City of Corpus Christi

Meeting Agenda - Final

Planning Commission

Wednesday, April 17, 2024

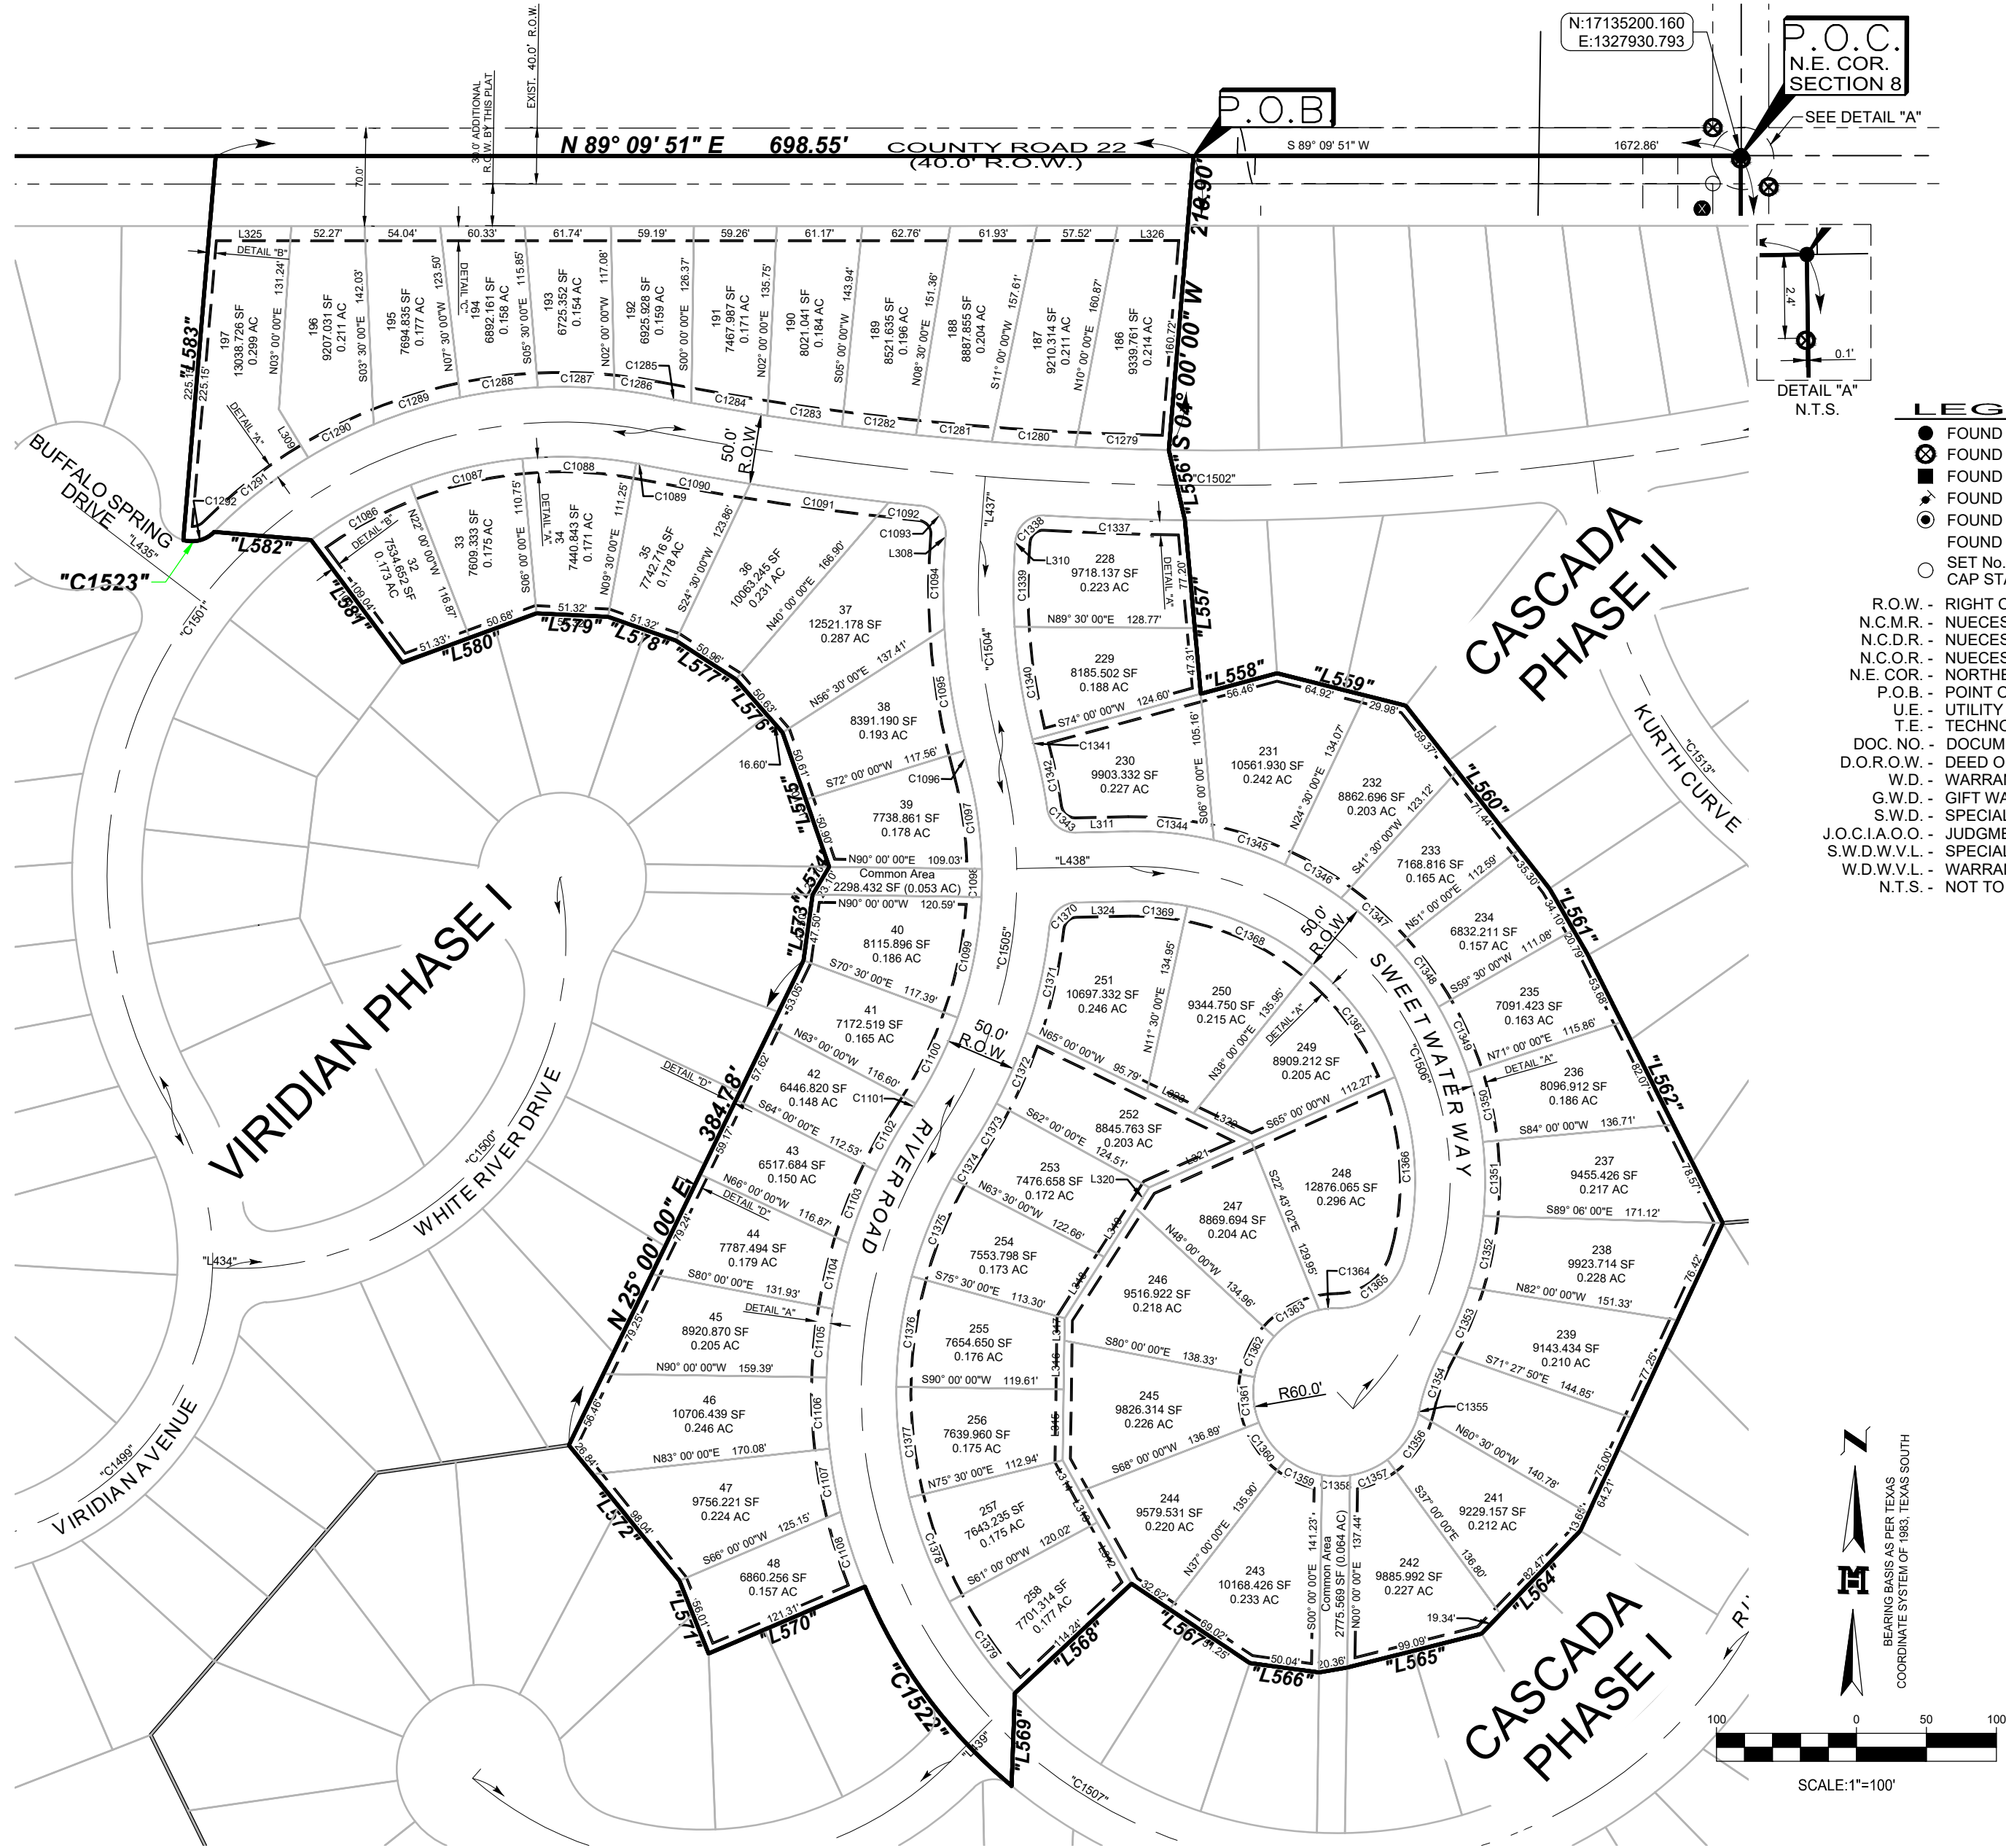
Comment ID	Page Reference	Annotation Type	Author : Department	Status	Review Comments	Applicant Response Comments
1	SHEET 1	Note	Mark Zans : DS	Open	Hatch the area to be street dedication and provide square footage of the area.	
2	SHEET 1	Note	Mark Zans : DS	Open	Move 10 U/E/ label to readable spot.	
3	SHEET 1	Note	Mark Zans : DS	Open	Provide street names. Street names should match names given on preliminary plat.	
4	SHEET 1	Note	Mark Zans : DS	Open	Place square footage of lots below lot number.	
5	SHEET 1	Note	Mark Zans : DS	Open	Name surrounding parcels with names associated with the other plats. and phases.	
6	SHEET 1	Note	Mark Zans : DS	Open	Label common areas as to usage.	
7	SHEET 1	Note	Mark Zans : DS	Open	Increase font size to make street names readable.	
8	SHEET 1	Note	Mark Zans : DS	Open	Please see City of Corpus Christi / Platting website for final plat templates and formatting.	
9	SHEET 1	Note	Mark Zans : DS	Open	Remove legal description from the plat page, not needed.

10	SHEET 1	Callout	Mark Zans : DS	Open	Change subdivision map to Final Plat of	
11	SHEET 1	Callout	Mark Zans : DS	Open	Change Phase name to something that makes sense.	
13	SHEET 1	Note	Mark Zans : DS	Open	Change plat format, please see City of Corpus Christi / Platting website for final plat formats.	
14	SHEET 1	Callout	Mark Zans : DS	Open	Fix signature line	
15	SHEET 1	Callout	Mark Zans : DS	Open	Change chairman's name to Michael Miller	
21	SHEET 1	Note	Mark Zans : DS	Open	Parks Dept. No comments Park Fee: 60 lots x 462.50 = \$27,750.00	
23	SHEET 1	Callout	Mark Zans : DS	Open	Add pahse name to Crosstown Coves	
24	SHEET 1	Note	Mark Zans : DS	Open	TxDOT comments- <input type="checkbox"/> No increase in storm water discharge to State right-of-way shall be accepted by TxDOT. <input type="checkbox"/> TxDOT Permits will be issued in accordance with the access management standards and all applicable state and federal laws, including rules

25	SHEET 1	Note	Mark Zans : DS	Open	<p>Fire comments 8-14</p> <p>8□ Infor, □ To negotiate a turn in a cul-de-sac, the minimum required distance is a 96 ft diameter in accordance with section 503.2.5 Dead ends. Dead-end fire apparatus access roads more than 150 feet (45 720 mm) in length shall be provided with an approved area for turning around fire apparatus. Turn around provisions shall be provided by means of a 96-foot diameter cul-de-sac (Section 503.2 and Appendix D. Cul -de -Sac turning diameter shall be 96 minimum.)</p> <p>9□ Infor, □ Note: An accessible road and a suitable water supply is required once construction materials are brought on site.</p> <p>10□ Infor: □ 503.4 Obstruction of fire apparatus access roads. Fire apparatus access roads shall not be obstructed in any manner, including the parking of vehicles. The minimum widths and clearances established in sections D103 shall always be maintained.</p> <p>11□ Infor: □ 503.3 Marking: Where required by the fire code official, approved signs, or other approved notices the include the words NO PARKING-FIRE LANE shall be provided for fire apparatus access roads to identify such roads to prohibit the obstruction thereof. The designation of a fire lane can be marked with conspicuous signs which have the words: Fire Lane-No Parking at 50-foot intervals. In lieu of signs, fire lanes may be marked along curbing with the wording, Fire Lane-No Parking at 15-foot intervals.</p> <p>12□ Infor. □ As the new subdivision develops, streets</p>

26	SHEET 1	Note	Mark Zans : DS	Open	<p>Fire comments - 1- 7</p> <p>1 Infor: Although presently this proposed subdivision is outside city limits, it is projected to be annexed soon. Consideration should be given to the standards for fire protection as follows:</p> <p>2 Utility Residential fire flow should have at least 750 GPM with fire hydrants spaced every 600 feet.</p> <p>3 Infor: 503.2.3 Surface. Fire apparatus access roads should be designed and maintained to support the imposed loads of fire apparatus and shall be surfaced to provide all weather driving capabilities and capable of supporting the imposed load of fire apparatus weighing at least 75,000 pounds.</p> <p>4 Infor: IFC 2015 Sec. 503.2.1 Dimensions Fire apparatus access roads shall have an unobstructed width of not less than 20 feet, exclusive of shoulders</p> <p>5 Infor: Where a hydrant is located on an fire apparatus access road, the minimum road width shall be 26 feet, exclusive of shoulders.</p> <p>6 Infor: "The minimum required width of 20 feet that shall be maintained means a clear unobstructed path that allows the passage of fire apparatus.</p> <p>1. Where Fire Apparatus Access is constructed to the minimum of 20 feet, no parking is allowed</p>

27	SHEET 1	Callout	Mark Zans : DS	Open	Insert phase name here	
28	SHEET 1	Note	Mark Zans : DS	Open	Please provide a addressed plat with addresses for each lot. Do not address the small common areas unless their is a building planned for the lot. (i.e. Clubhouse,, HOA office)	
29	SHEET 1	Note	Mark Zans : DS	Open	AEP Texas Distribution request a 5 electric easement in the front of every lot off the ROW for front lot distribution. It can be the first 5 or the second behind a UE if there is one.	
32	SHEET 1	Note	Mark Zans : DS	Open	<p>Traffic comments 1-8</p> <p>1 Plat Lack of Public Improvement Plans present difficulty to justify variable right-of-way widths interanal to the subdivision.</p> <p>2 Informational: All new streetlight systems in residential subdivisions shall utilize concrete poles per IDM Chapter 8 section 1.2.B.a</p> <p>3 Plat Curvilinear nature of Roadway layout may require lighting above and beyond the minimum 500 ft spacing</p> <p>4 Informational: Proposed driveway access to a public City Street shall conform to access management standards outlined in Article 7 of the UDC (UDC 7.1.7)</p> <p>5 Informational: Per urban trasnportation masterplan CR22 is Nueces County Right of Way. Developer to coordinate access to CR22 with Nueces County</p>

33	SHEET 1	Note	Mark Zans : DS	Open	<p>Traffic comments 9 - 16</p> <p>9□Informational:□Pavement markings shall be installed within the scope of the subdivision in accordance to specifications of, and subject to, latest version of the "Texas Manual on Uniform Traffic Control Devices (TMUTCD), public improvement plan reviews and inspections, by the City. Reference: Texas MUTCD based on CC UDC Article 8.1.3.A</p> <p>10□Informational:□Pavement markings shall be installed within the scope of the subdivision on all streets classified as a collector (C1) or higher on the City's Urban Transportation Plan Map. Streets not designated as a collector (C1) or higher, but constructed with a 40-foot width (back-of-curb to back-of-curb) will be subject to specifications stated in public improvement plan review. Reference: Texas MUTCD based on CC UDC Article 8.1.3.A</p> <p>11□Informational:□Raised blue pavement markers in accordance with the latest version of the "Texas Manual on Uniform Traffic Control Devices (TMUTCD)," shall be installed in the center of a</p>

36	SHEET 1	Note	Mark Zans : DS	Open	GIS comments- The plat does not close within acceptable engineering standards.	
37	SHEET 1	Note	Mark Zans : DS	Open	It is department understanding that zoning is to be RS-4.5. Front yard setback for this zoning is 25'. Please depict this setback of 25 feet and label it 25' Y.R.	
16	SHEET 2	Callout	Mark Zans : DS	Open	Change to final Plat of Crosstown Coves	
17	SHEET 2	Callout	Mark Zans : DS	Open	Change Phase name to something that makes sense.	
18	SHEET 2	Callout	Mark Zans : DS	Open	Fix signature line.

Comment ID	Page Reference	Annotation Type	Author : Department	Status	Review Comments	Applicant Response Comments
19	SHEET 2	Callout	Mark Zans : DS	Open	Change to sheet 2 of 2	
20	SHEET 2	Note	Mark Zans : DS	Open	Increase font size to make streets readable.

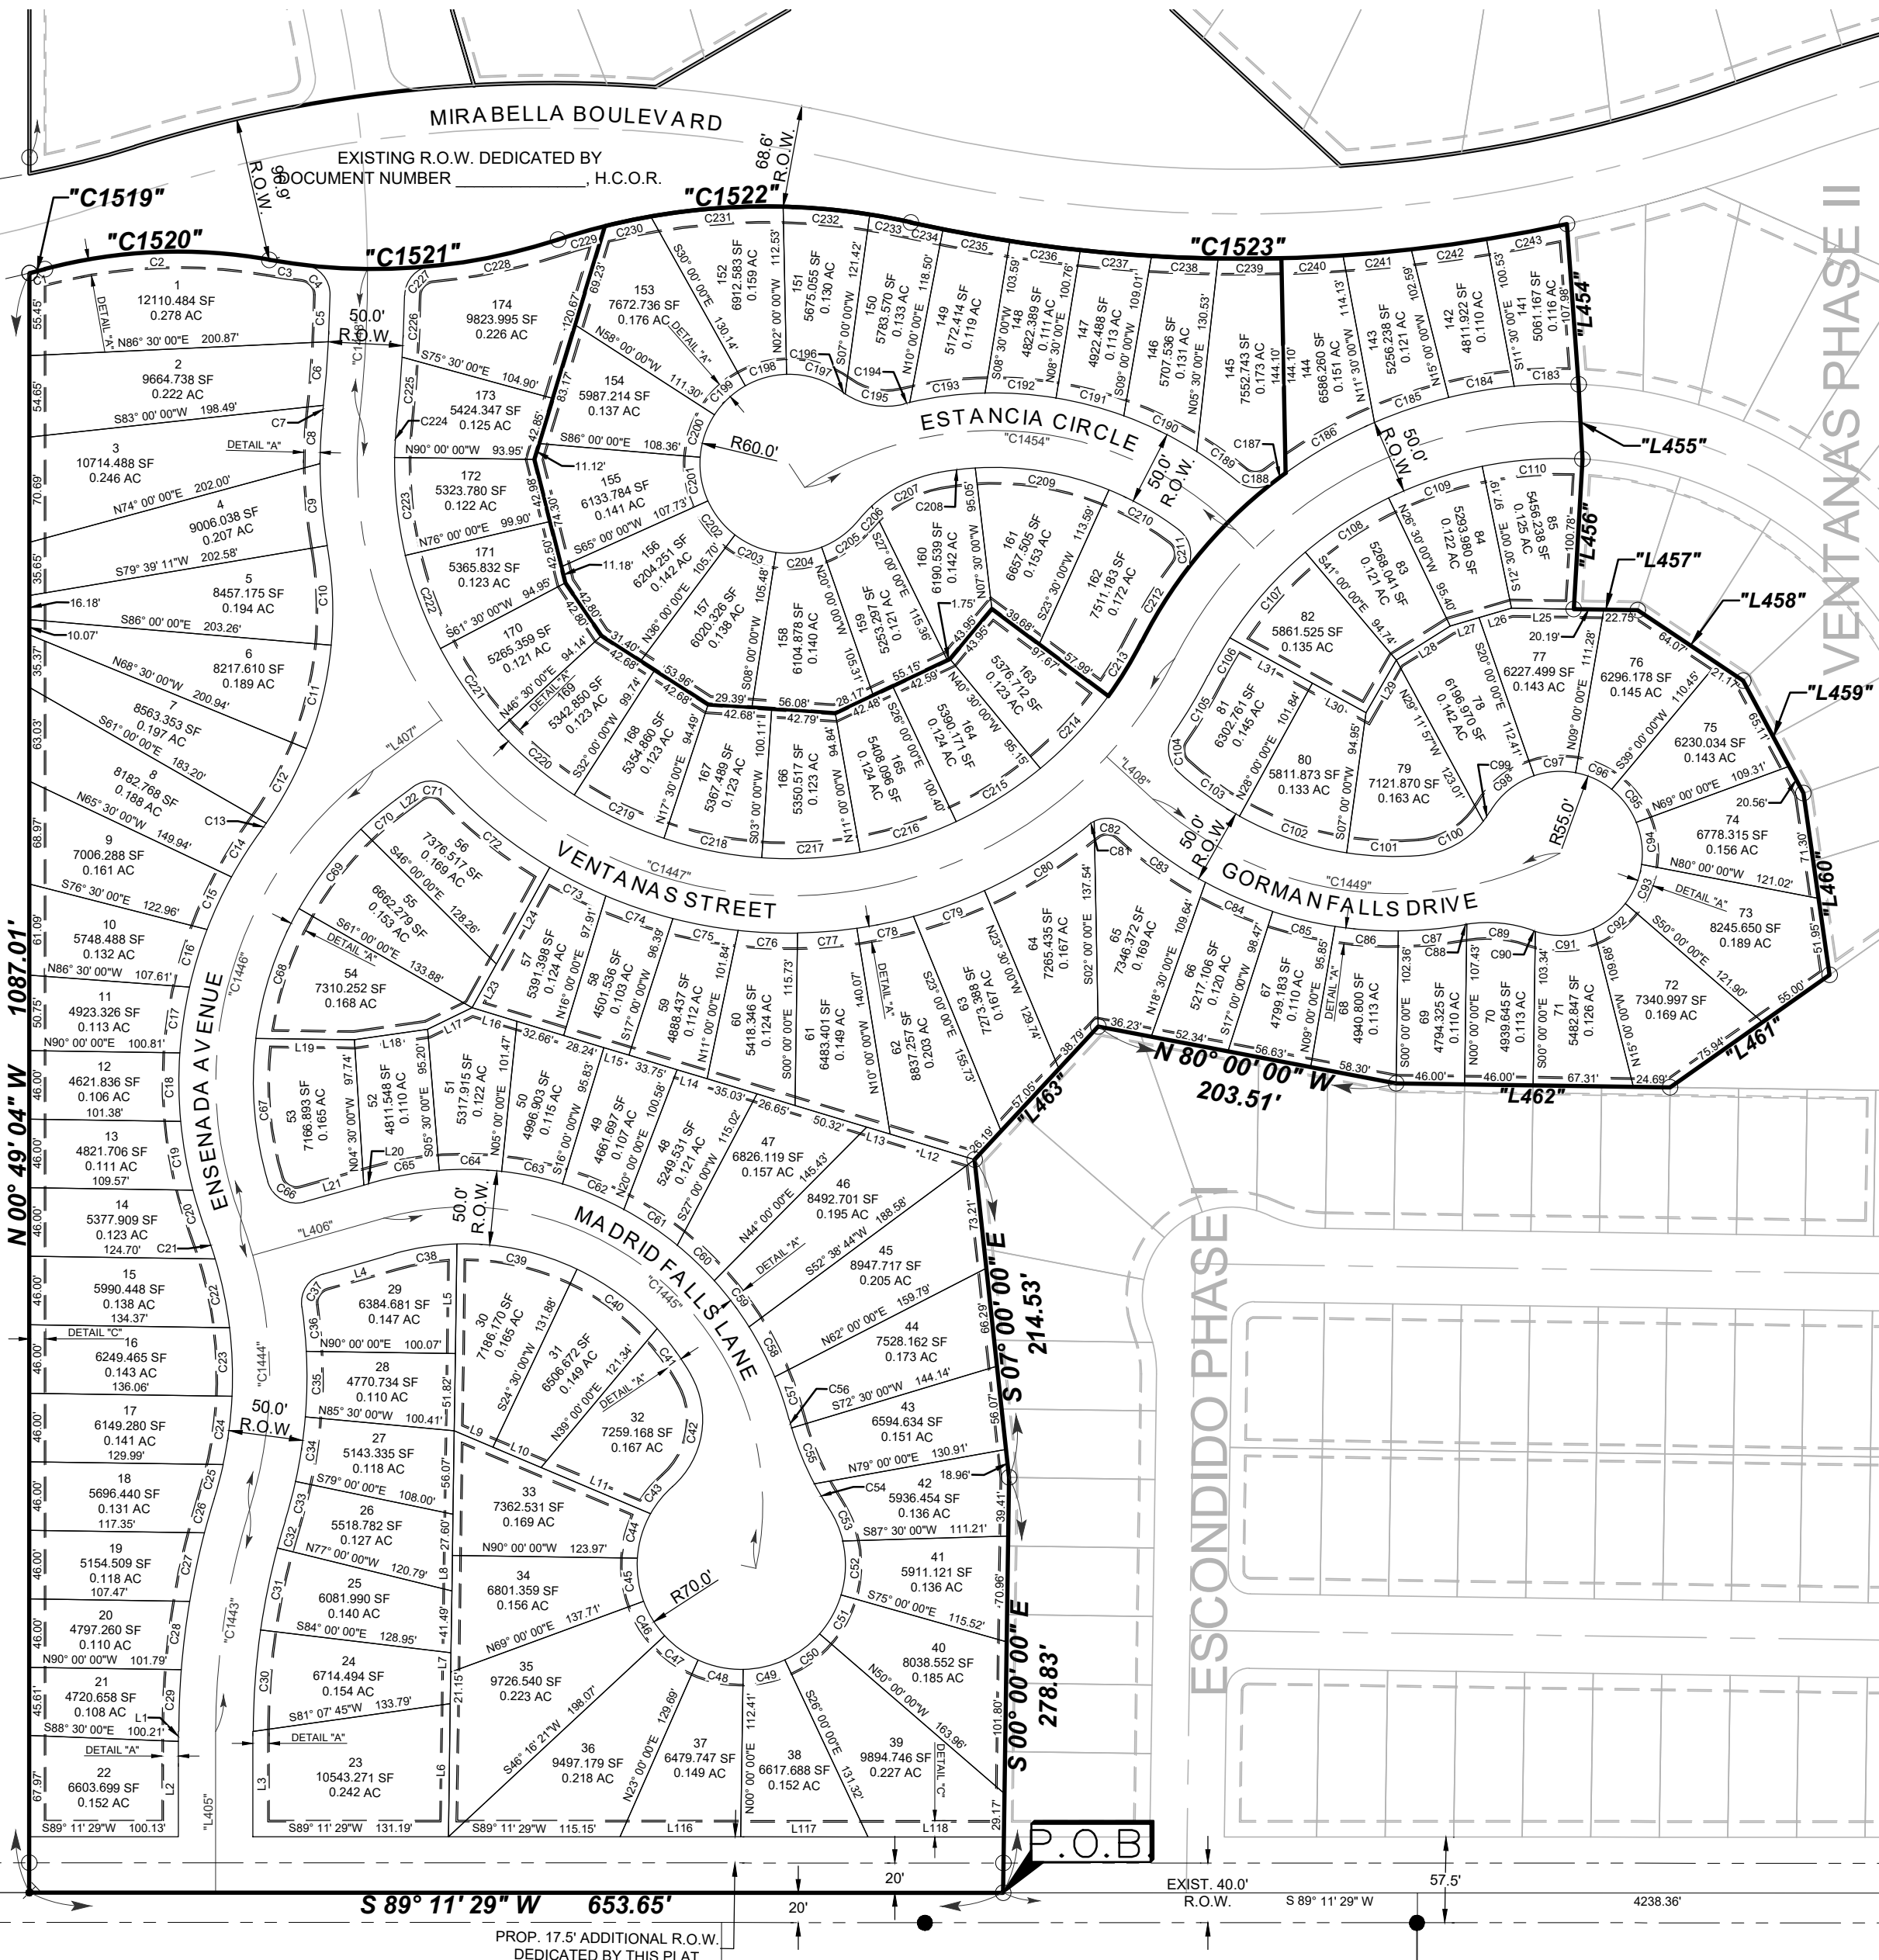
Comment ID	Page Reference	Annotation Type	Author : Department	Status	Review Comments	Applicant Response Comments
2	24022-Entry Phase I-Plat.pdf	Note	Mark Zans : DS	Open	Please see City of Corpus Christi / Platting for final plat templates for information and plat formatting.	
3	24022-Entry Phase I-Plat.pdf	Note	Mark Zans : DS	Open	Hatch area to be dedicated for ROW and provide square footage of the area.	
4	24022-Entry Phase I-Plat.pdf	Note	Mark Zans : DS	Open	Hatch area to be dedicated for ROW and provide square footage of the area.	
5	24022-Entry Phase I-Plat.pdf	Note	Mark Zans : DS	Open	Label easement areas as to type and width.	
6	24022-Entry Phase I-Plat.pdf	Note	Mark Zans : DS	Open	Place square footage of lots below the lot number.	
7	24022-Entry Phase I-Plat.pdf	Note	Mark Zans : DS	Open	Provide street names for the plat. Street names shall match those that are shown on the preliminary plat.

8	24022-Entry Phase I-Plat.pdf	Note	Mark Zans : DS	Open	Label adjacent properties with the plat phase if appropriate.	
9	24022-Entry Phase I-Plat.pdf	Note	Mark Zans : DS	Open	Label adjacent properties with the plat phase if appropriate.	
10	24022-Entry Phase I-Plat.pdf	Note	Mark Zans : DS	Open	Provide block numbers for the plat.	
11	24022-Entry Phase I-Plat.pdf	Note	Mark Zans : DS	Open	Label any common area with usage.	
12	24022-Entry Phase I-Plat.pdf	Note	Mark Zans : DS	Open	Remove the legal description from the plat. is not needed.	
13	24022-Entry Phase I-Plat.pdf	Callout	Mark Zans : DS	Open	Change subdivision map to Final Plat of Crosstown Coves	
14	24022-Entry Phase I-Plat.pdf	Callout	Mark Zans : DS	Open	Change phase name to something that makes sense.	
15	24022-Entry Phase I-Plat.pdf	Note	Mark Zans : DS	Open	Increase font size to make streets readable.	
16	24022-Entry Phase I-Plat.pdf	Callout	Mark Zans : DS	Open	Make this page 2 of 2

Comment ID	Page Reference	Annotation Type	Author : Department	Status	Review Comments	Applicant Response Comments
27	24022-Entry Phase I-Plat.pdf	Note	Mark Zans : DS	Open	<p>TxDOT comments-</p> <ul style="list-style-type: none"> □No increase in storm water discharge to State right-of-way shall be accepted by TxDOT. □TxDOT Permits will be issued in accordance with the access management standards and all applicable state and federal laws, including rules and regulations. Access connection spacing, materials, geometrics, accessibility, and other design specifications will be considered, as well as the impact on drainage and hydraulics, utility location or relocation, and the environment that will result from the requested construction of an access connection. 43 Tex. Admin. Code 11.52 (2020). □Drainage improvements shall accommodate runoff from the upstream drainage area in its anticipated maximum "build-out" or "fully developed" condition, and shall be designed to prevent overloading the capacity of the downstream drainage system □If the owner responsible for maintenance of the permanent stormwater or water quality control fails to maintain the control to TXDOT ROW, the owner shall correct the problem

28	24022-Entry Phase I-Plat.pdf	Note	Mark Zans : DS	Open	<p>Fire comments 1-7</p> <p>1□Infor:□Although presently this proposed subdivision is outside city limits, it is projected to be annexed soon. Consideration should be given to the standards for fire protection as follows:</p> <p>2□Utility□Residential fire flow should have at least 750 GPM with fire hydrants spaced every 600 feet.</p> <p>3□Infor:□503.2.3 Surface. Fire apparatus access roads should be designed and maintained to support the imposed loads of fire apparatus and shall be surfaced to provide all weather driving capabilities and capable of supporting the imposed load of fire apparatus weighing at least 75,000 pounds.</p> <p>4□Infor:□IFC 2015 Sec. 503.2.1 Dimensions Fire apparatus access roads shall have an unobstructed width of not less than 20 feet, exclusive of shoulders</p> <p>5□Infor: □Where a hydrant is located on an fire apparatus access road, the minimum road width shall be 26 feet, exclusive of shoulders.</p> <p>6□Infor.□"The minimum required width of 20 feet that shall be maintained means a clear unobstructed path that allows the passage of fire</p>

Comment ID	Page Reference	Annotation Type	Author : Department	Status	Review Comments	Applicant Response Comments
					19 Informational: Working without an approved ROW Construction Permit will be considered non-compliance and can be subject to fines and / or citations.	
40	24022-Entry Phase I-Plat.pdf	Note	Mark Zans : DS	Open	It is the understanding of the DSD that the zoning for this plat is to be RS-4.5. Front yard setback for zoning RS-4.5 is 20 feet. Please depict and label a 20' Front yard setback for each lot.	
17	24022-Entry Phase I-Plat2.pdf	Callout	Mark Zans : DS	Open	Make this page 1 of 2	
18	24022-Entry Phase I-Plat2.pdf	Callout	Mark Zans : DS	Open	Change subdivision map to Final Plat of crosstown Coves	
19	24022-Entry Phase I-Plat2.pdf	Callout	Mark Zans : DS	Open	Change Phase name to something that makes sense.	
20	24022-Entry Phase I-Plat2.pdf	Callout	Mark Zans : DS	Open	Add Phase name to Crosstown Coves name
